## Service Bulletin No. 070

### Alternator Model ALV-9510R Rotor Shaft O-Ring and Spacer Replacement

Figure 1 - ALV-9510R Alternator Rotor Shaft Spacer, O-Ring & Washer Stack

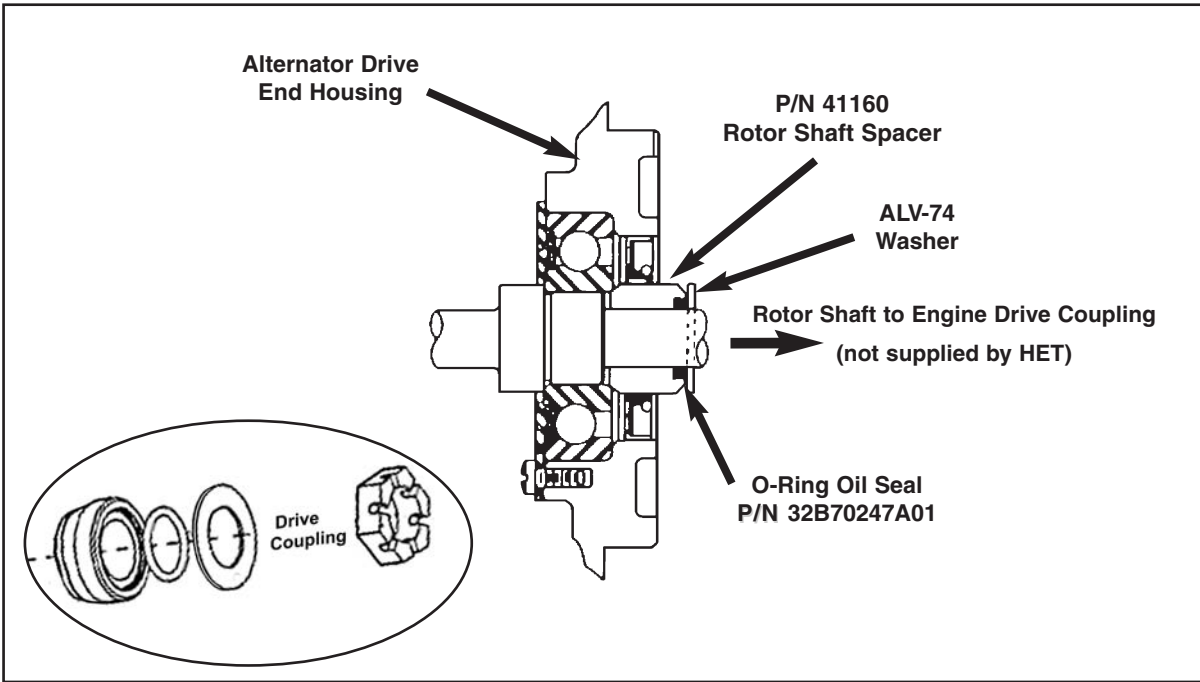
- (1) Affected alternator models ALV-9510R may have a condition where the O-ring for the rotor shaft spacer may be sized incorrectly. This condition may exist in rotor shaft spacers manufactured from September 20, 2006 through December 07, 2016.

- (2) This condition may lead to the loss of alternator drive coupling nut torque.
- (3) Left uncorrected over time, a complete loss of alternator drive coupling nut torque could result in damage to the alternator drive coupling and/or engine drive gear.
- (4) Regulatory action is unknown.

- (3) Disassemble the alternator only to the extent that will allow replacement of the O-ring and rotor shaft spacer. Refer to Fig. 1.
    - (a) Remove and discard the woodruff key, HET P/N X-0260.

- (b) Remove the large washer, HET P/N ALV-74.
    - (c) Remove and discard the existing O-ring and rotor shaft spacer, HET P/N ALV-0210.
  - (4) Assemble the rotor shaft spacer and O-ring on the alternator rotor shaft.

- (a) Install the new rotor shaft spacer HET P/N 41160 (will have an identification groove on the OD, refer to Fig. 2), with the O-ring gland facing outward.

- (b) Install a new O-ring, HET P/N 32B70247A01. (Put a drop of aircraft engine oil on the O-ring to ease installation over the rotor shaft.)
    - (c) Install the large washer, HET P/N ALV-74.

- (d) Install a new woodruff key, HET P/N X-0260.
  - (5) Prior to installing the Engine Drive Gear Coupling, it must be inspected and found to be airworthy in accordance with the engine or coupling manufacturers latest service information.

Figure 2 - P/N 41160 Alternator Rotor Shaft Spacer Identification (identification groove and wide O-ring Gland)

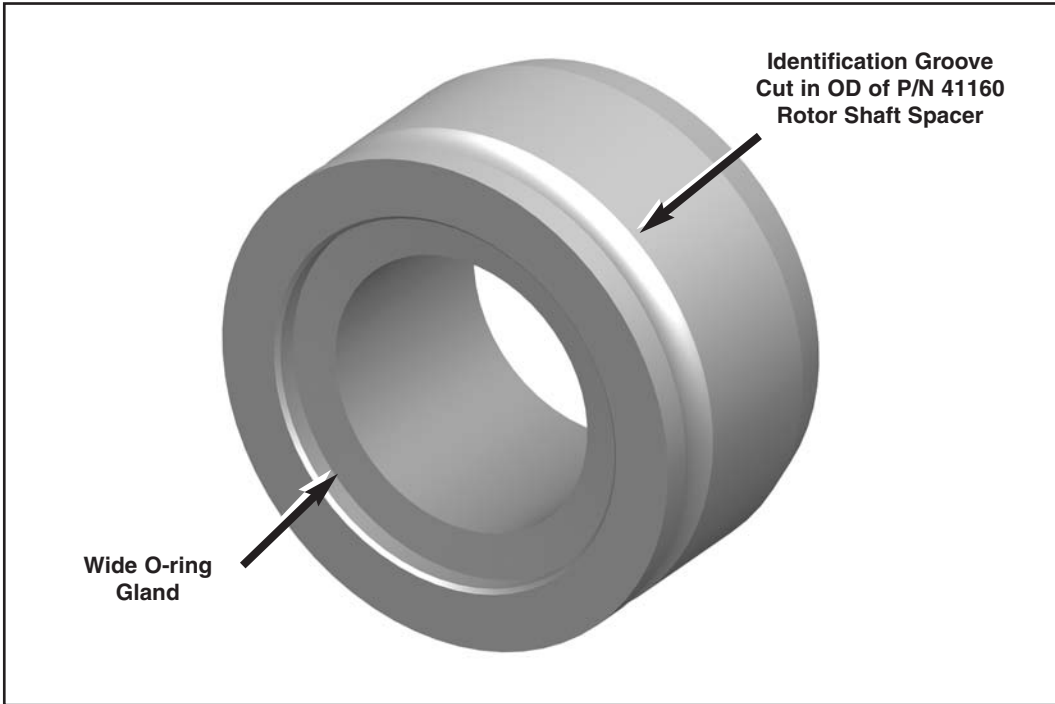
- (1) This Service Bulletin provides Instructions for Continued Airworthiness (ICA).
- (2) This Service Bulletin requires replacement at the next service interval of the rotor shaft spacer P/N ALV-210 and O-ring (all installed) with rotor shaft spacer HET P/N 41160 and O-ring HET P/N 32B70247A01 in ALV-9510R alternators with serial numbers shown in Table 1 and any serial number with affected kit HET P/N 90-2822 installed between September 20, 2006 through December 07, 2016.
